APPLICATION NOTE 41D

DECREASING THE RESPONSE TIME OF THE MODEL 405 INPUT FILTER

Figure 2.

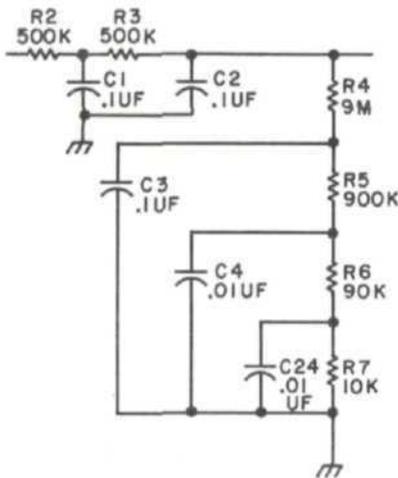
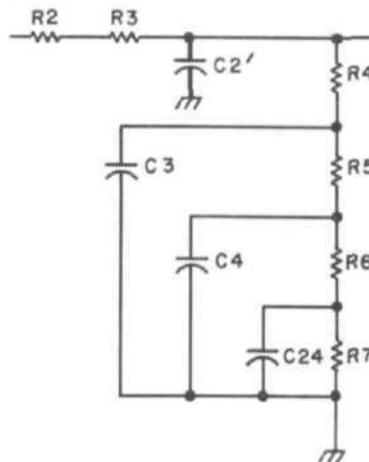
Modification 1 - To reduce the response time on the $\pm .999$ volt range, remove C1 and replace C2 with a $0.01 \mu\text{f}$, 1000 vdcw polystyrene capacitor. For convenience, two $0.02 \mu\text{f}$ 600 vdcw capacitors may be used in series.

Input Filter Modified for Fast Response on $\pm .999$ V Ranges

Figure 3.

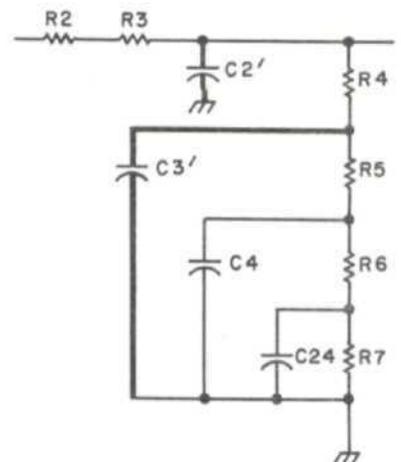
Modification 2 - To reduce the response time on all ranges, perform Modification 1 and in addition remove C3 and replace with a $0.01 \mu\text{f}$, 600 vdcw polystyrene or mylar dielectric capacitor.

Input Filter Modified for Fast Response on all Ranges
